Re: Shell Station Addition – Eisenhower and Saline-Ann Arbor Road

On behalf of Cranbrook Village Limited Partnership (“Cranbrook”) I provide the following response (shown in CAPS RED) to Mr. Todd Quatro’s correspondence of June 18, 2019 regarding the additional building and other changes proposed at the Shell Gas Station site located at 2679 Saline-Ann Arbor Road (“Proposed Project”).

## SHELL STATION ADDITION - SUMMARY OF COMMENTS ON SITE PLAN REV. 7

PROJECT NO.: 2886  
SHEET TITLE: TITLE SHEET  
SHEET NO.: TS1.0

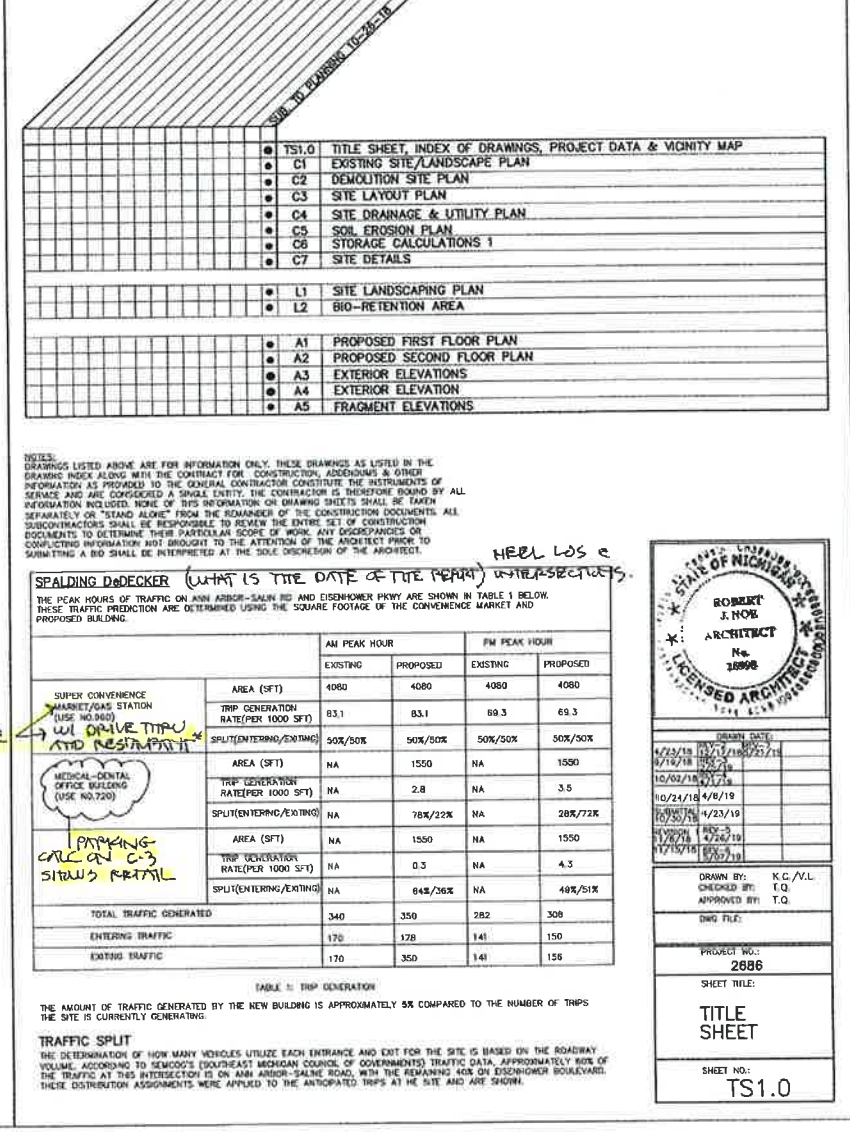
**SPALDING DeDECKER (WHAT IS THE DATE OF THE PERMITS) INTERSECTIONS.**

PROJECT NO.: 2688  
SHEET TITLE: EX. SITE/LANDSCAPE PLAN  
SHEET NO.: C1

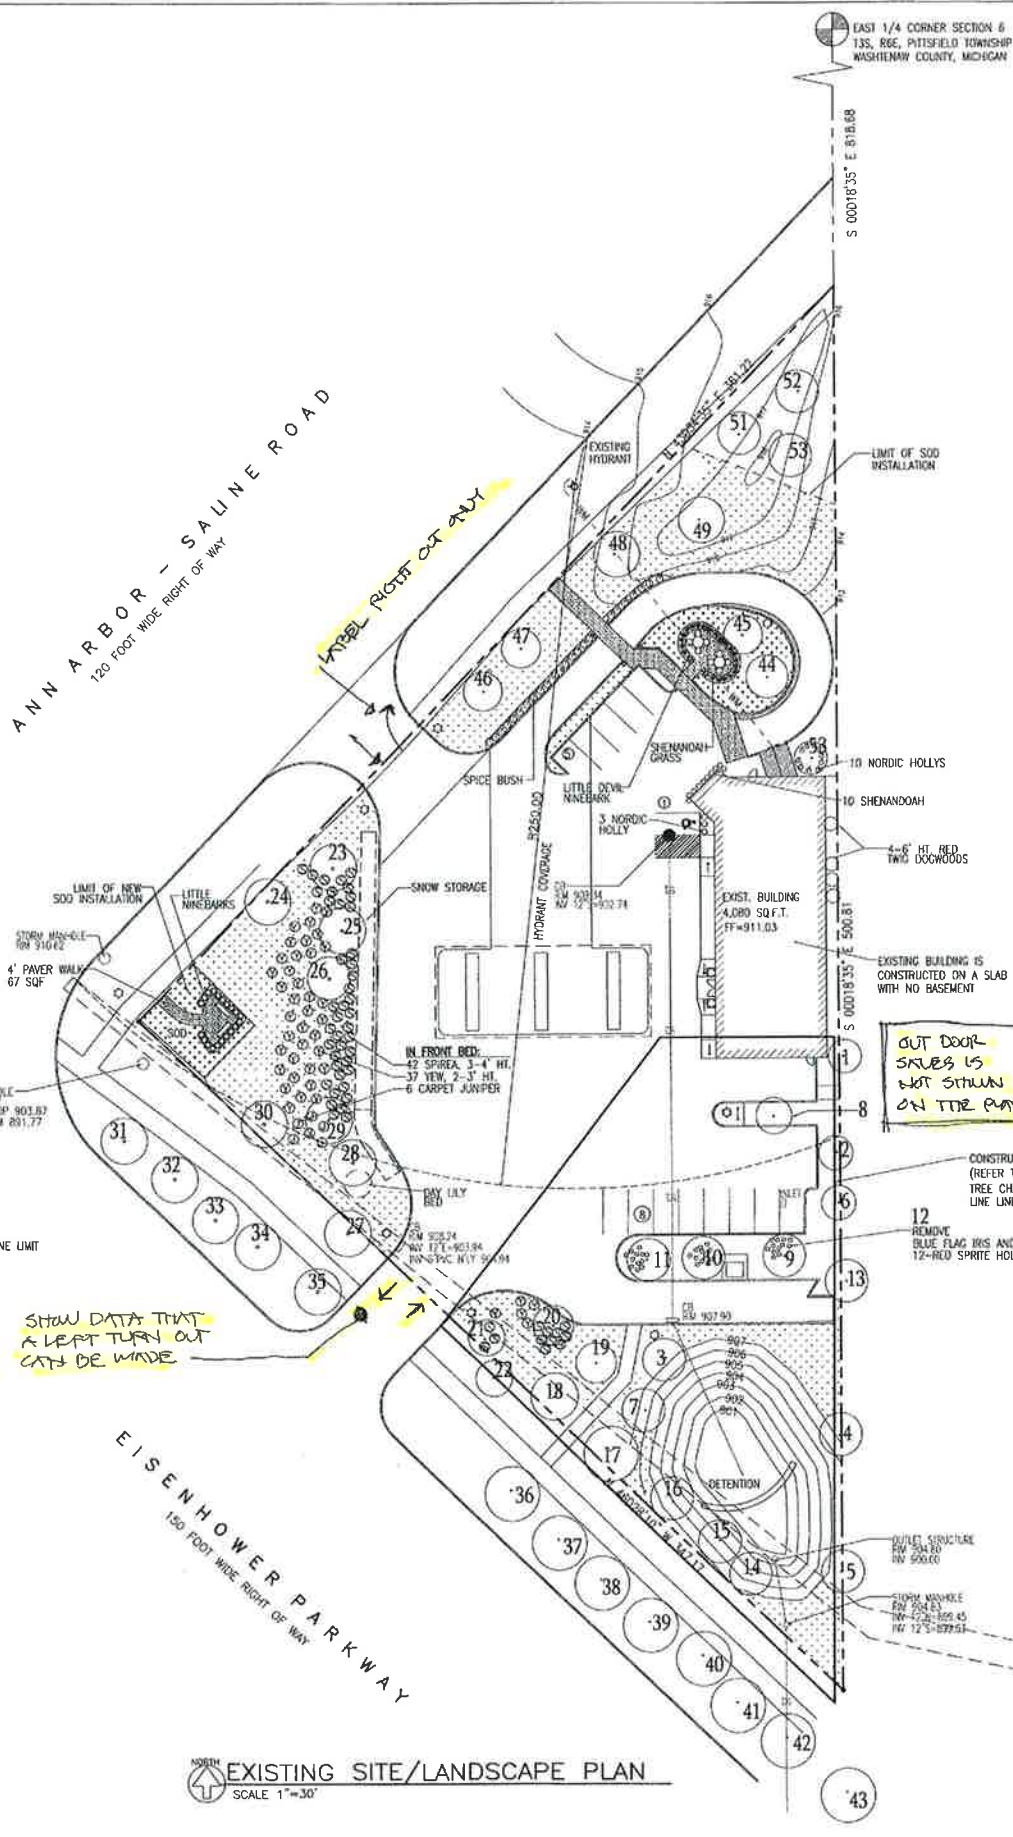
The required information required by the Checklist of Required Information for Site Plan (Ann Arbor requirements) is missing, including;

The curb cuts do not show the existing turning movements.

#23-26 ON CHART ARE NOT INCLUDED WITHIN THE CONSTRUCTION LINE LIMIT (REFERENCE LANDSCAPE ISLAND THAT IS IN THE CORNER OF EISENHOWER PKWY AND ANN ARBOR-SALINE RD)

SHOW DATA THAT A LEFT TURN OUT CATCH BE WASTE

PROVIDE ALL INFORMATION FROM THE CHECKLIST OF REQ'D INFORMATION FOR SITE PLANS INCLUDING BUT NOT LIMITED TO:

OUT DOOR SALES IS NOT SHOWN ON THE PLAN

SHEET NO: C3

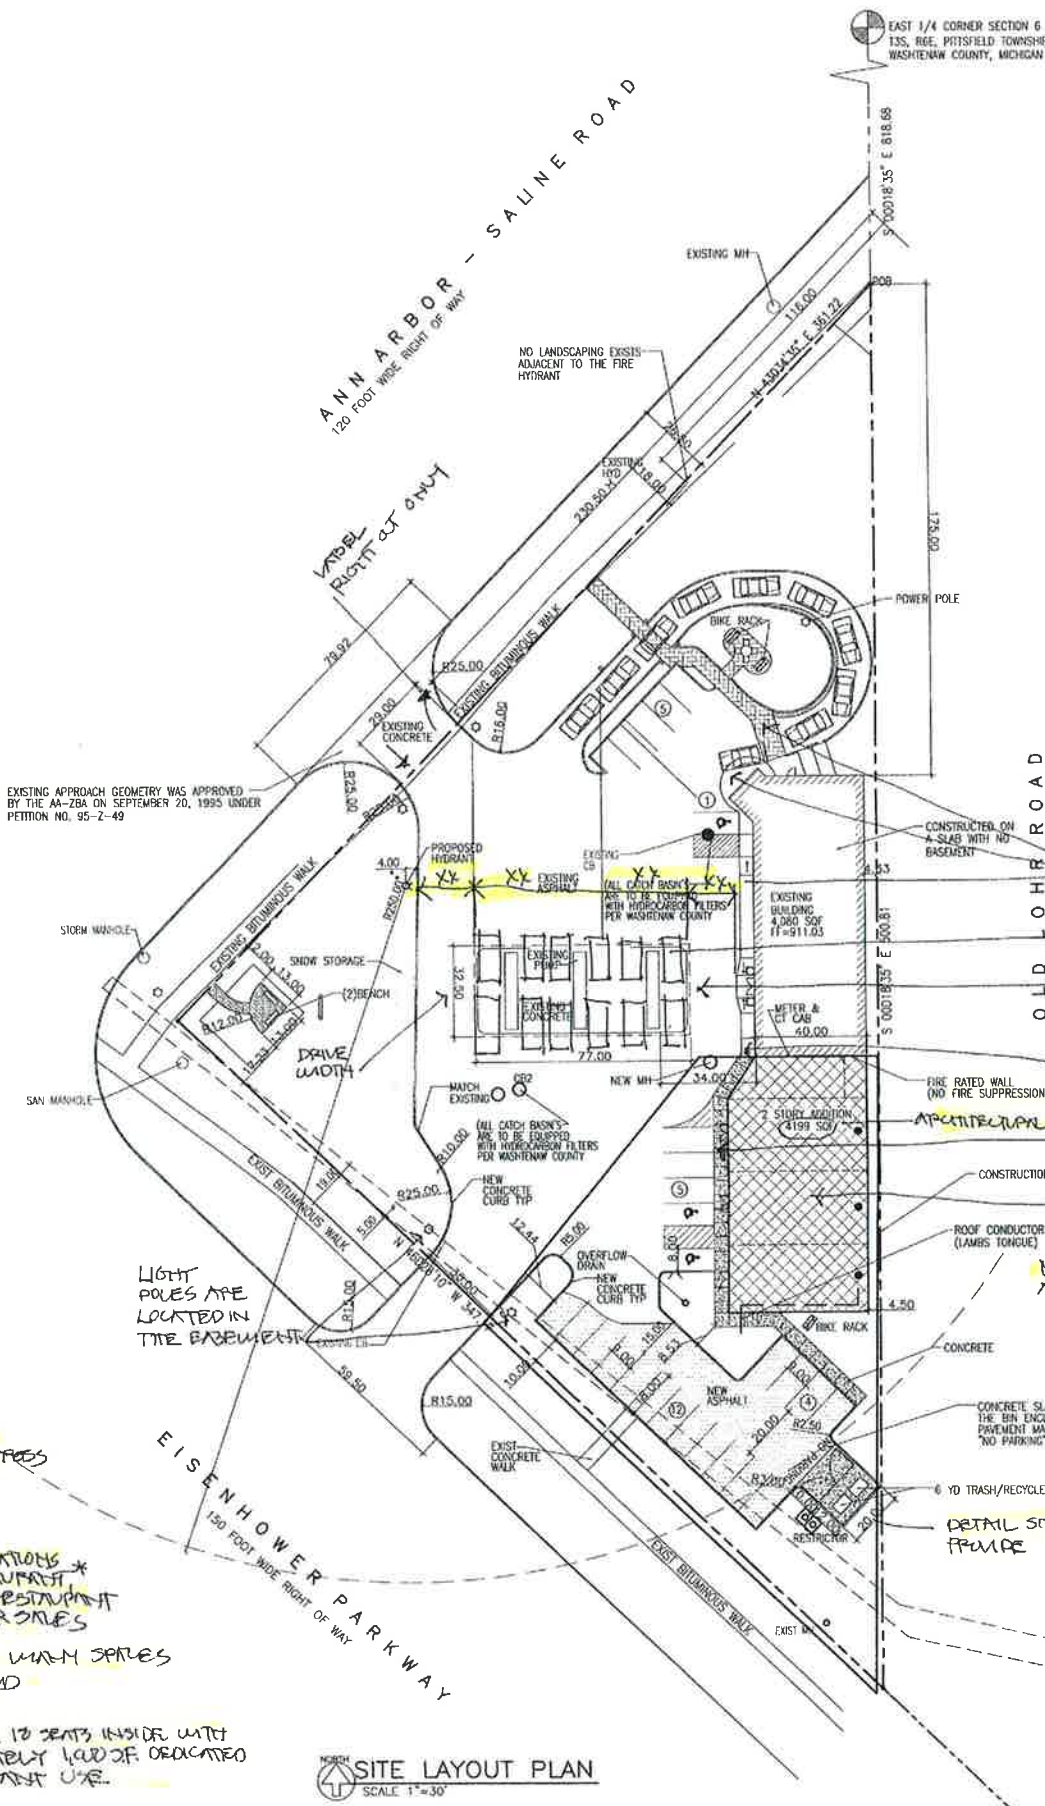
Show outdoor sales and the it's required parking calculations.

Show the accessible route to the existing and proposed building.

The building area on the addition is not accurate as compared to the floor plan.  
No loading is provided.  
The required parking calculation is not correct including, parking for **drive thru restaurant**, retail, convenience store, and office.  
The amount of parking spaces provided is not provided.  
Dimensions are not shown for the existing or proposed building.  
The curb cuts are not labeled with the turning movements. Not sure if a car can turn right in and left out of the Eisenhower curb cut.  
Dumpster dimensions do not match the details on sheet C-7  
There are light fixtures in an easement along Eisenhower.  
The building areas of the addition are incorrect.

PROVIDE CALCULATIONS FOR THE RESTAURANT DRIVE THRU RESTAURANT AND OUT DOOR SEAT. PROVIDE HOW MANY SPACES ARE PROVIDED.

PROVIDE 12 SEATS INSIDE WITH APPROXIMATELY 1/2 OF DEDICATED TO RESTAURANT USE.

SHEET NO.:  
A1

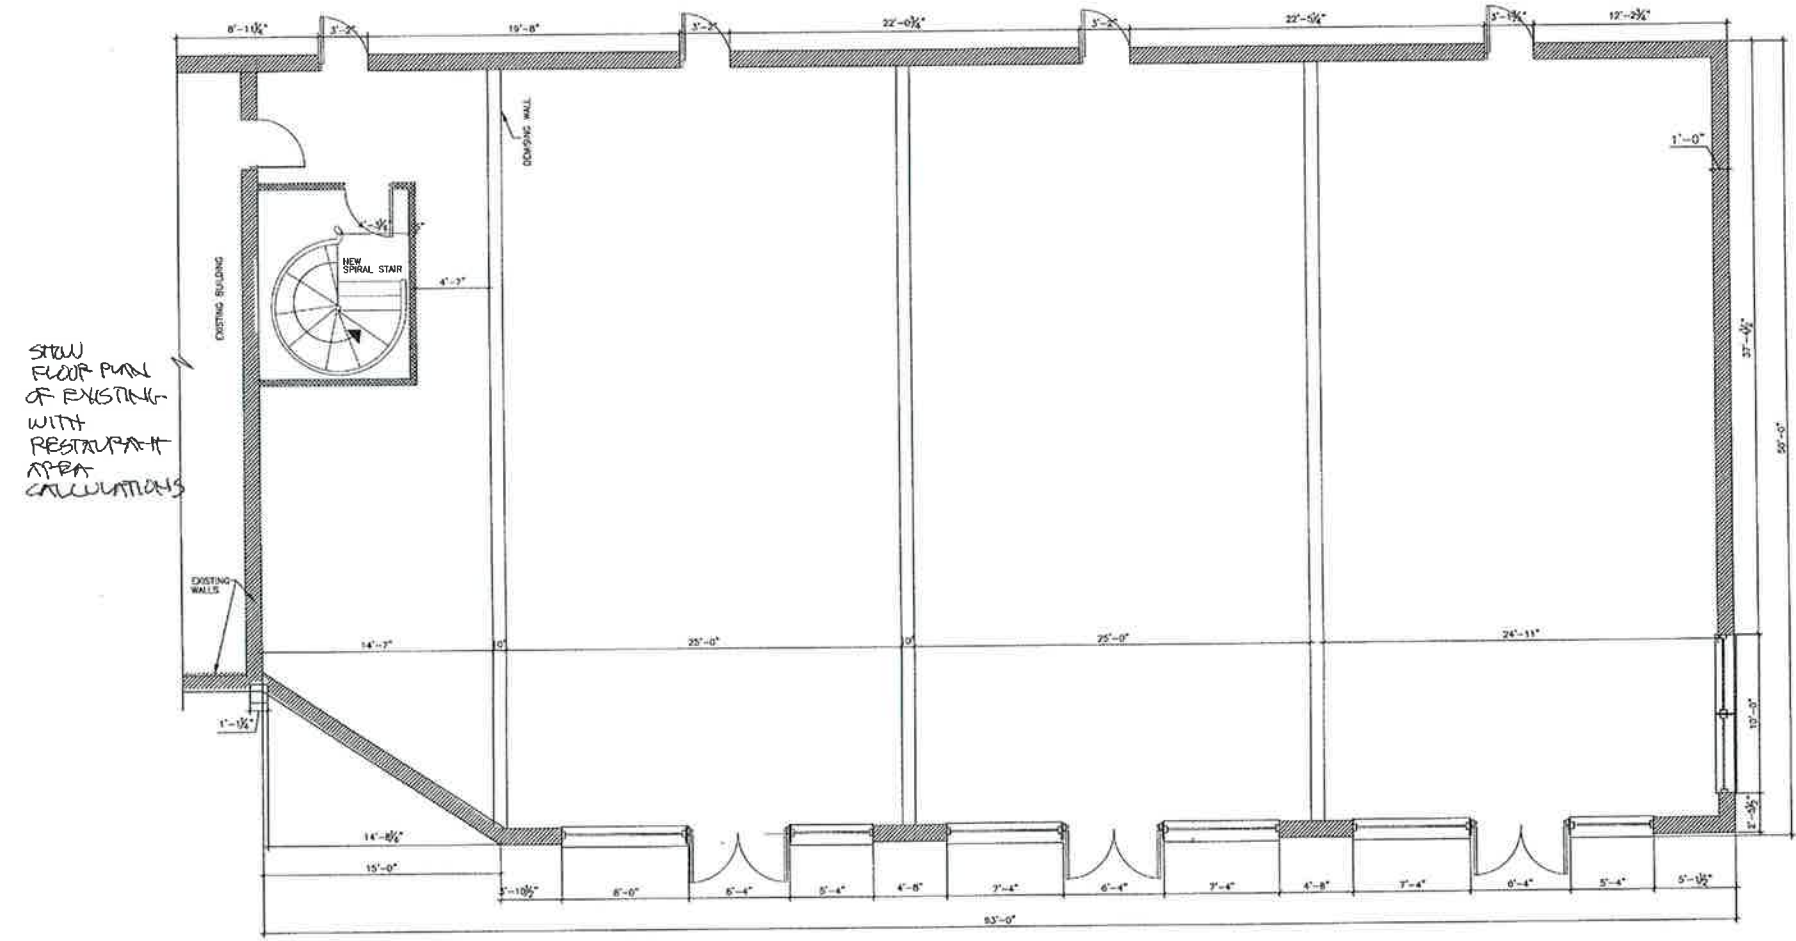
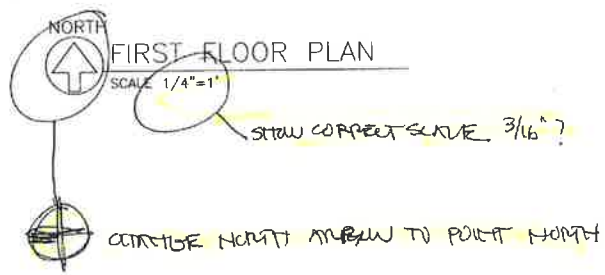
North arrow is incorrect.  
Building area and all dimensions are not provided.  
The scale is incorrect.  
Provide existing building floor plan with all dimensions and area calculations of all the uses including the restaurant.

SHOW FLOOR PLAN OF EXISTING RESTAURANT AREA CALCULATIONS

SHEET NO.: A3

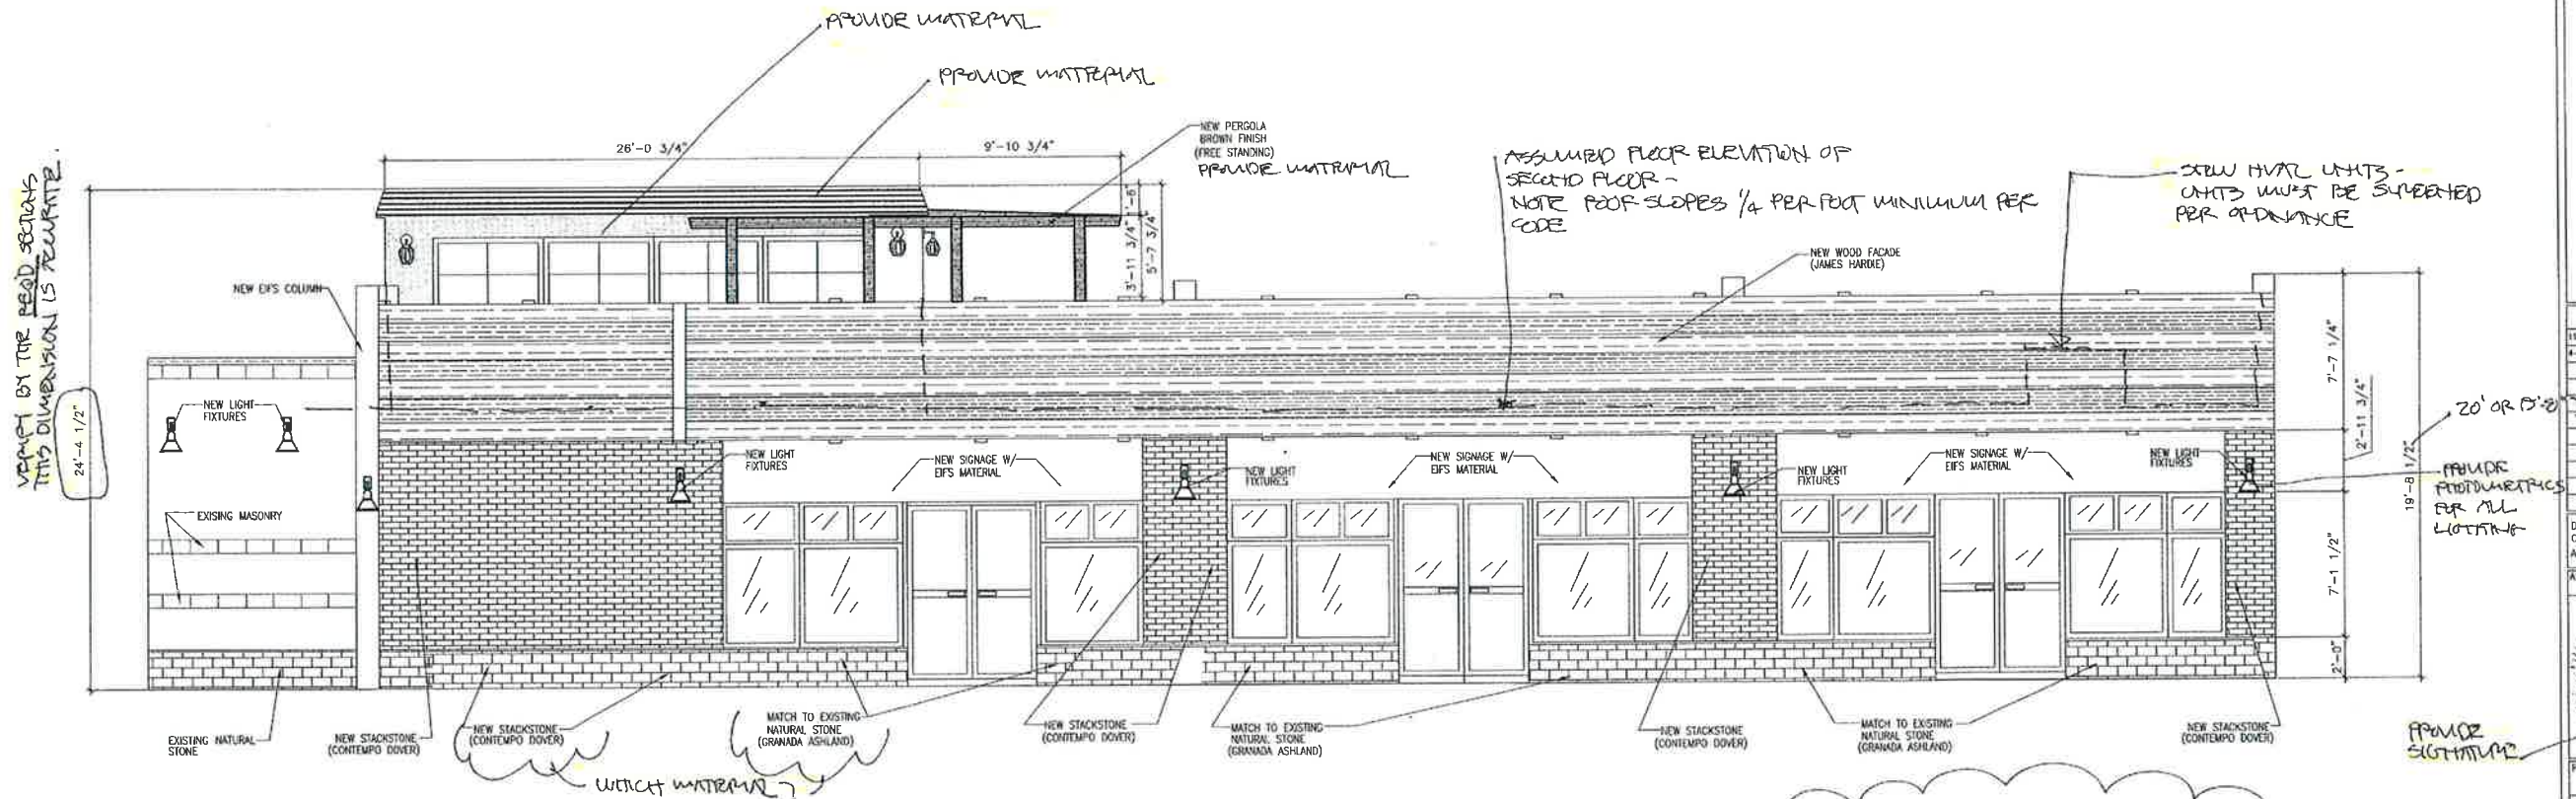
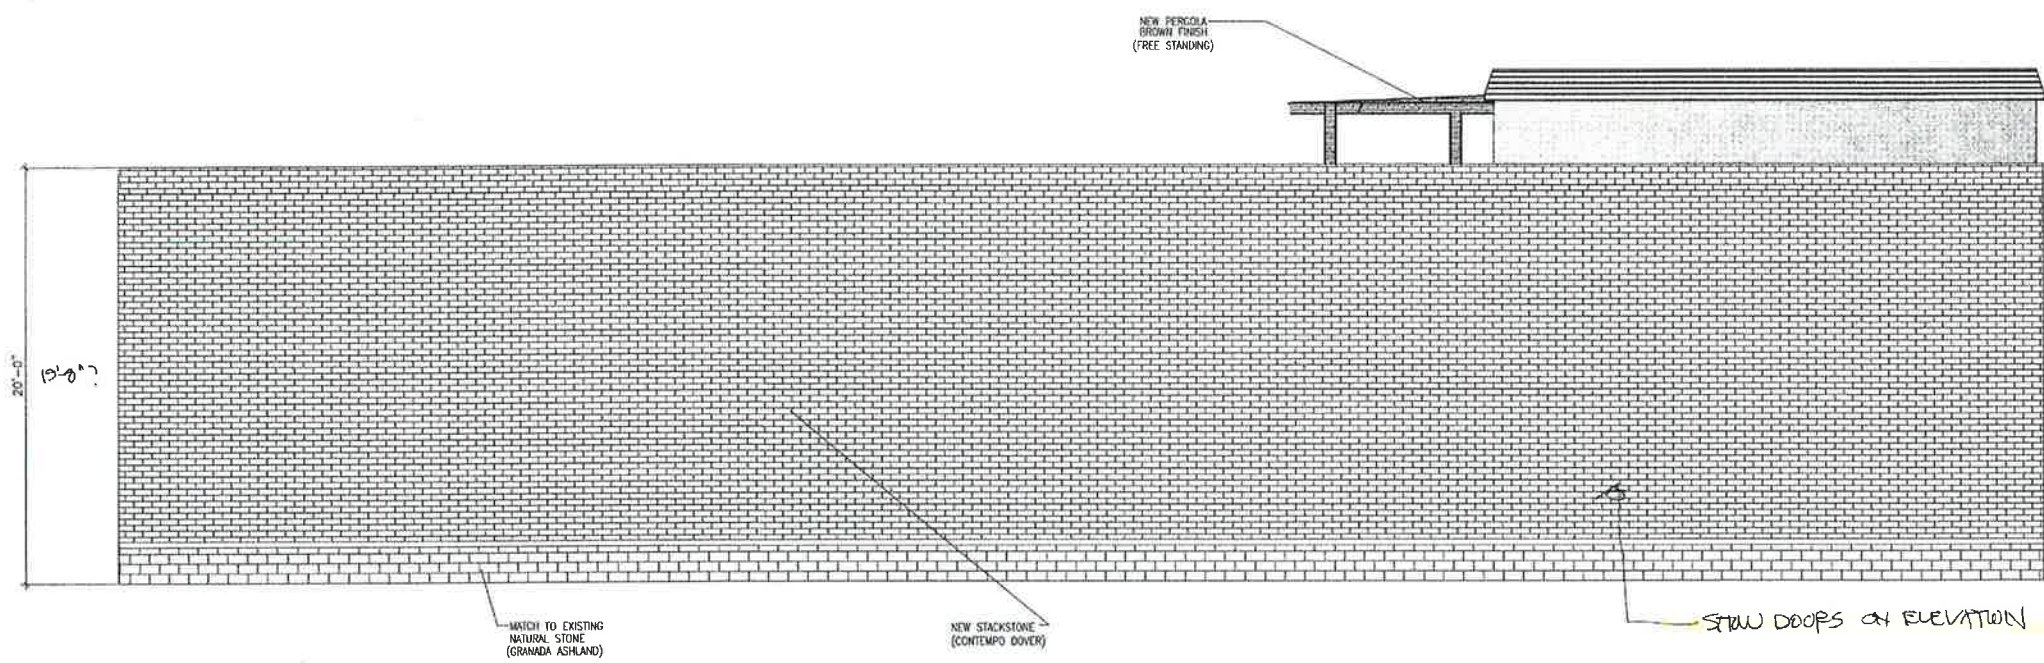
Provide 3-D renderings, as required by the City, of the entire new and proposed building.  
The elevations are hatched as brick where stone is labeled.  
The vertical dimensions are not consistent from elevation to the other.  
Show how the HVAC units are being screened.  
Provide a detail of the James Hardy siding, the drawing is unclear.
